Access Compliance Report

Public Rights-of-Way

(Curb Ramps)

Intersection ID: 31549	Main Street: CROSS_ST	Cross Street: RED_SHED_LN	Location: NE
ADA ID: 09B29CE698A6	Ramp Type: PerpDiag	Initial Pass/Fail: Pass	Overall Compliance: No
		Severity Score: 12.5

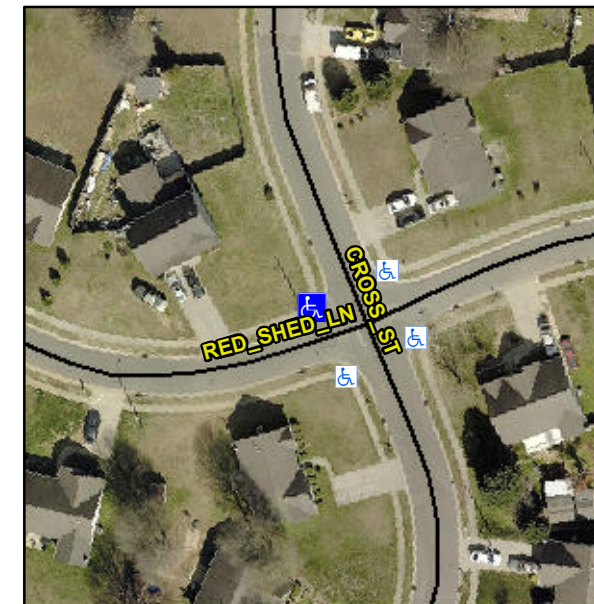
Not Found, R304.2.2-Perp, R304.3.2-Para, R305.2, R302.7.2, R304.5.4

Compliance	Description	Data	Compliance	Description	Data
N/A	Ramp Length (in)	42.5	Yes	Ramp Slope (%)	7.1
Yes	Ramp Width (in)	48.0	Yes	Ramp XSlope (%)	2.0
N/A	Flare Type LT	Sloped	N/A	Flare Type RT	N/A
N/A	Flare Slope LT (%)	12.4	N/A	Flare Slope RT (%)	8.4
N/A	Flare Traversable LT?	No	N/A	Flare Traversable RT?	No
Yes	Landing Length (in)	50.5	Yes	DWS Provided?	Yes
Yes	Landing Width (in)	48.0	Yes	DWS Contrast?	Yes
No	Landing Slope (%)	5.8	Yes	DWS Length (in)	25.5
Yes	Landing X Slope (%)	1.6	Yes	DWS Full Width?	Yes
N/A	Landing Curb? (Y/N)	No	No	DWS Offset (in)	3.0
N/A	Shared Landing?	No			
Yes	Gutter Ponding?	No	No	Gutter Slope (%)	10.0
No	Gutter Lip Ht (in)	0.5	Yes	Gutter X Slope (%)	1.3
N/A	Painted X Walk1?	No	N/A	Painted X Walk2?	No
	X Walk 1 Direction	To S		X Walk 2 Direction	To E
N/A	X Walk 1 Width (in)	N/A	N/A	X Walk 2 Width (in)	N/A
	X Walk 1 Slope (%)	0.9		X Walk 2 Slope (%)	1.1
	X Walk 1 X Slope (%)	3.1		X Walk 2 X Slope (%)	0.8

N/A	Ramp inside XWalk1?	N/A	N/A	Ramp inside XWalk2?	N/A
	Road Slope (%)	0.2	N/A	Clear Space?	Yes
	Road X Slope (%)	0.1	N/A	Clear Space to XWalk (in)	N/A
Yes	Any Obstructions?	No	Yes	Storm Grate/Utility Hazard?	No
	Obstruction Type			Storm Grate/Utility Type	
		N/A			N/A
		Yes		Surface Condition? (G/P)	Good

Remove & Replace Curb Ramp With Two New Directional Ramps or Equivalent. Remove & Replace Gutter.
